# Product Change Notification

Product Change Notification: PCN-24-201503

Platinum thin film temperature sensors on ceramics substrate

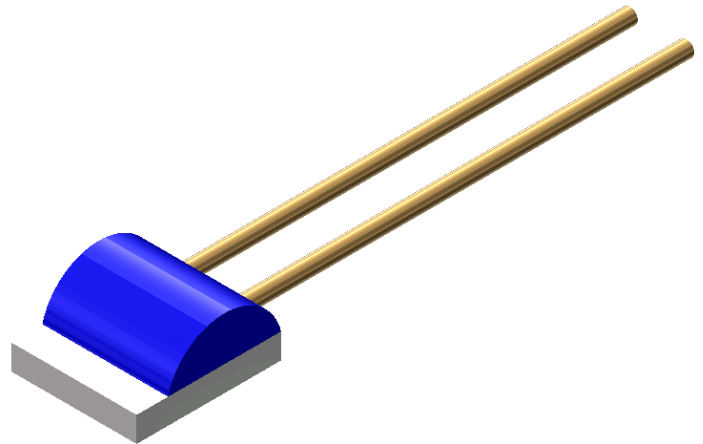
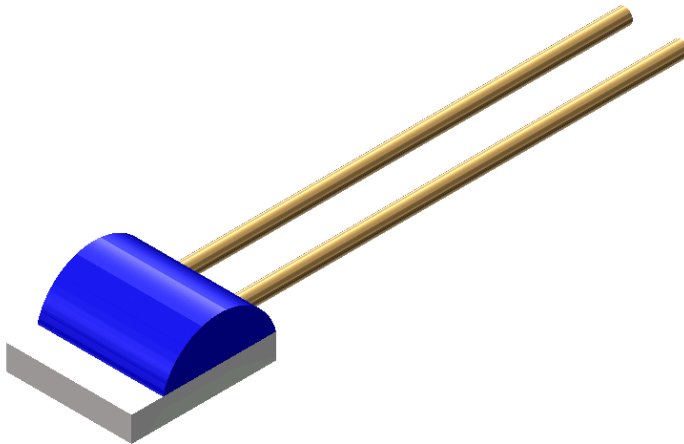
Change blue fixation material to lead free composition. Slightly change of blue color can occur compared to the current state.

Composition of blue wire fixation material contents some lead. This is currently covered by an exceptional permission.

New fixation material is lead free now and complies to RoHS. No exceptional permission needed.

The current pin fixation material composition contents lead (Pb) which is currently handled by an exception regulation. To keep the parts RoHS compliant in the future the fixation material composition is changed to a lead free composition.
